## Public Input No. 116-NFPA 79-2022 [ Section No. 1.4 ]

## Public Input No. 117-NFPA 79-2022 [ New Section after 1.6 ]

**Figure D.1(e) Elementary Schematic.**

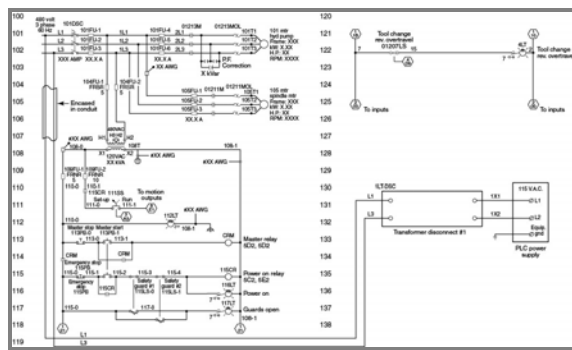
In Figure D.1(e) the word "conduit" is being changed to "raceway" to be consistent with the change made in 5.1.13.2

**Figure D.1(e) Elementary Schematic.**

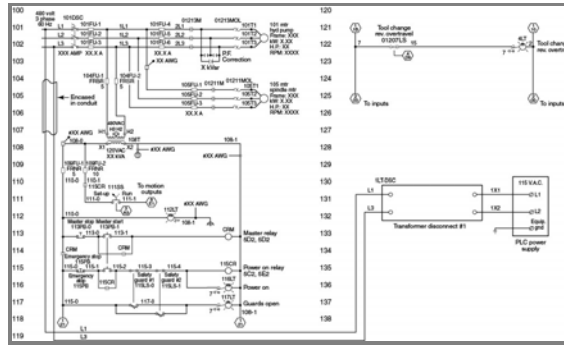
Figure D.1(e)

Change "Encased in conduit" to "Encased in a raceway".

This PI is related to PI 119 for 5.1.13.2(2)

In Figure D.1(e) the word "conduit" is being changed to "raceway" to be consistent with the change made in 5.1.13.2

Figure D.1(e) Elementary Schematic.

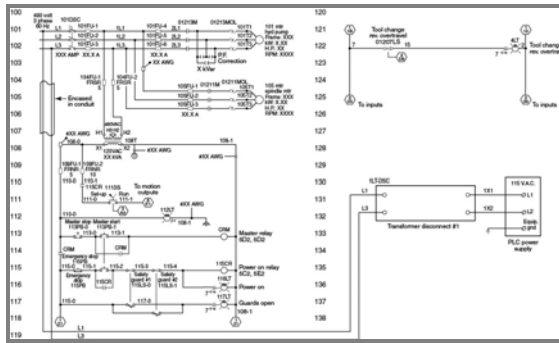
In Figure D.1(e) the word "conduit" is being changed to "raceway" to be consistent with the change made in 5.1.13.2
